**JORDAN VALLEY WATER CONSERVANCY DISTRICT
JWTP BACKWASH OUTLET VALVE
REPLACEMENT PROJECT
DISTRICT PROJECT NO. 4349**

FEBRUARY 2026

ADDENDUM NO. 1

SCALE:
 DATE
1/29/2026
 PROJECT NUMBER
4349
 DRAWING NUMBER
E1
 SHEET NUMBER
3 OF **4**

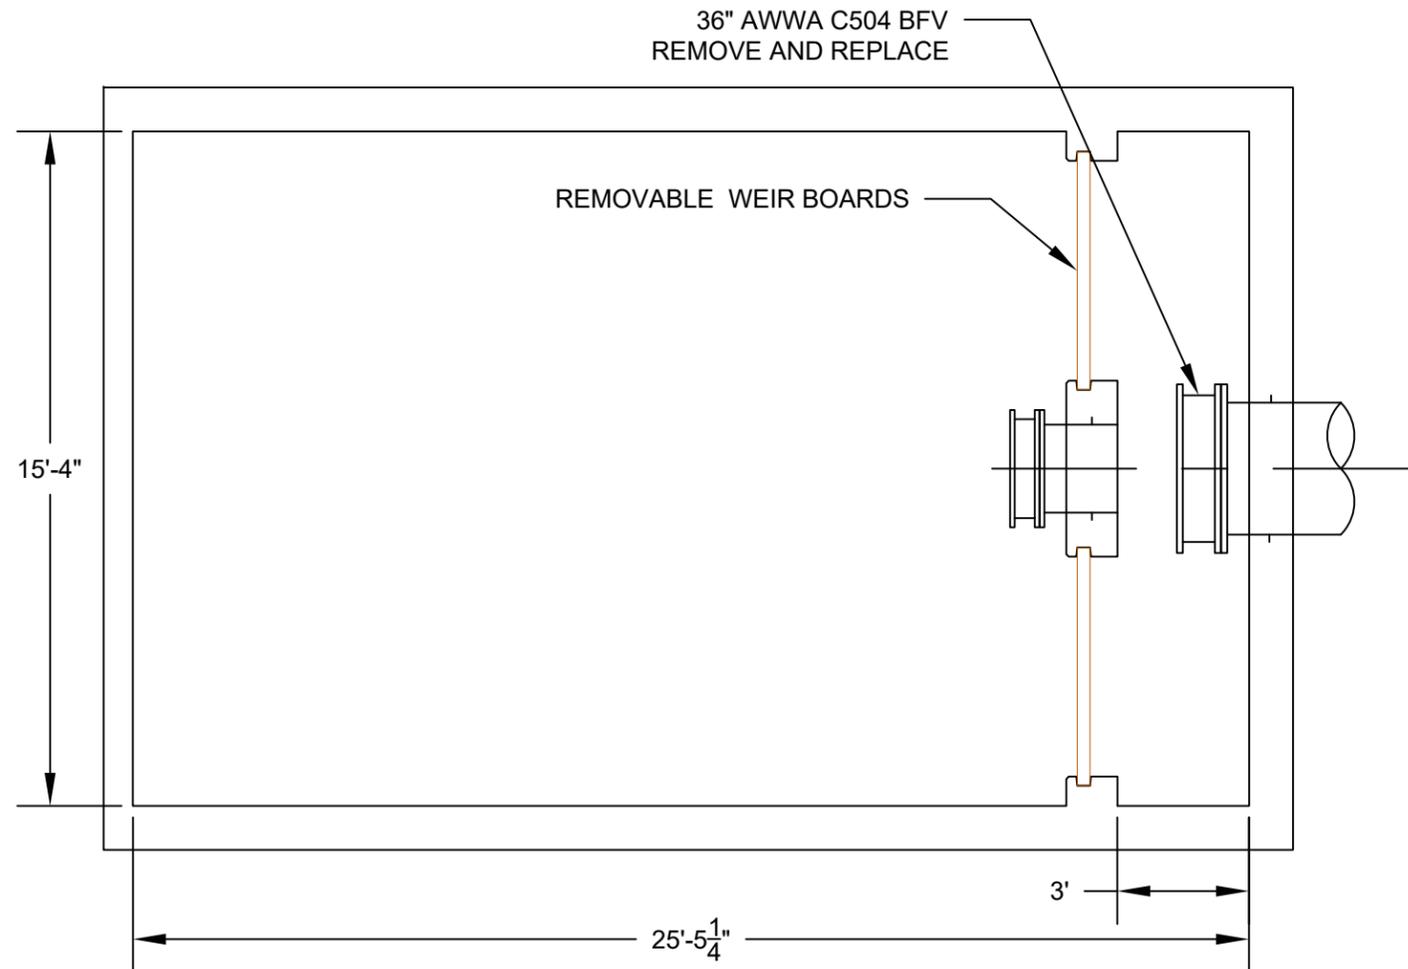
- 1.1.1** Drawing E1, callouts on the plan view were missing on the original drawing set.

SCALE:
DATE
1/29/2026
PROJECT NUMBER
4349
DRAWING NUMBER
C1
SHEET NUMBER
4 OF 4

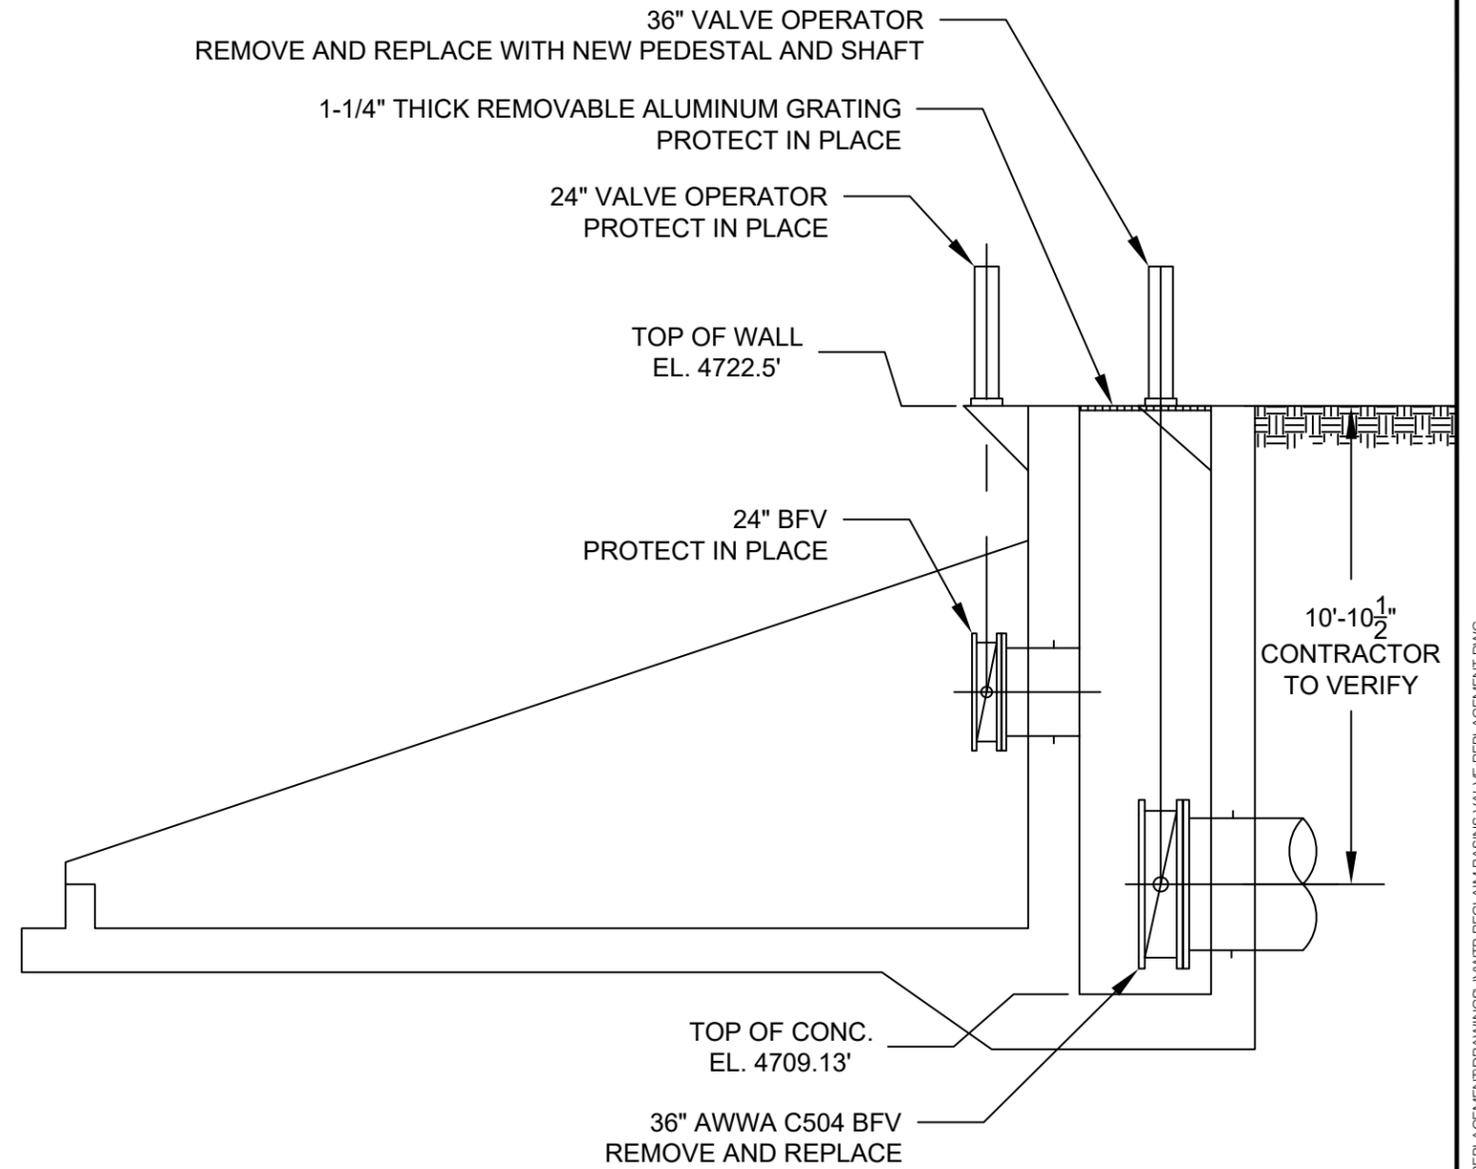
- 1.1.2** Drawing C1, the valve orientation in the plan view and section view were contradicting each other. The plan view was updated to reflect the desired mounting position.
